From: Jack Karagoz [REDACTED] >
Sent: 21 July 2026 09:32
To: Simon Davis; Rebecca Hornsby
Subject: RE: WA/18/26/PL - Land off Arundel Road

We note that the LLFA have raised several points on our previous responses (attached), which are set out below along with our response to each point. If possible we would be happy to have a quick teams meeting with you and the LLFA to talk through the remaining points rather than going back and forth every few weeks. Is this something you might be able to arrange?

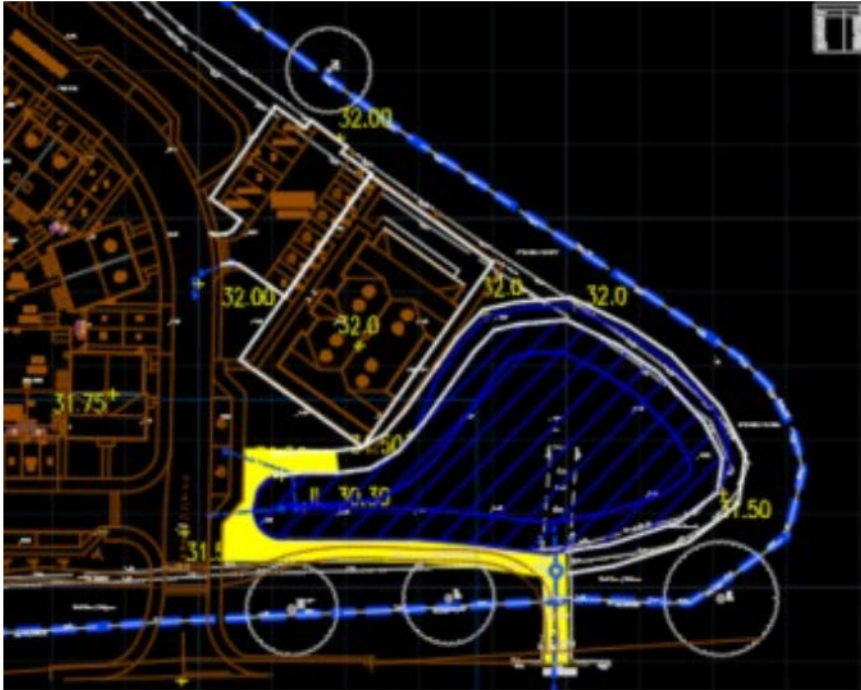
A minimum 3m easement for the attenuation basin is required, for maintenance access.

The easement shall go around the entire basin, rather than part of it. For the side near the building, it is unclear whether the basin can be safely maintained. As these issues could affect the layout and scale of the site, it would not be reasonable for the above to be covered via conditions at this stage

We have currently shown a 3m easement for maintenance for the inlet and outlet structures. Any other maintenance can be carried out from within the basin.

Notwithstanding the above we can tweak the layout to provide the 3m easement around the entire perimeter as below.

We are happy to make the above amendments, however before making change to the layout we would like clarification of the first point along with acceptance to the departure to Standard 2.
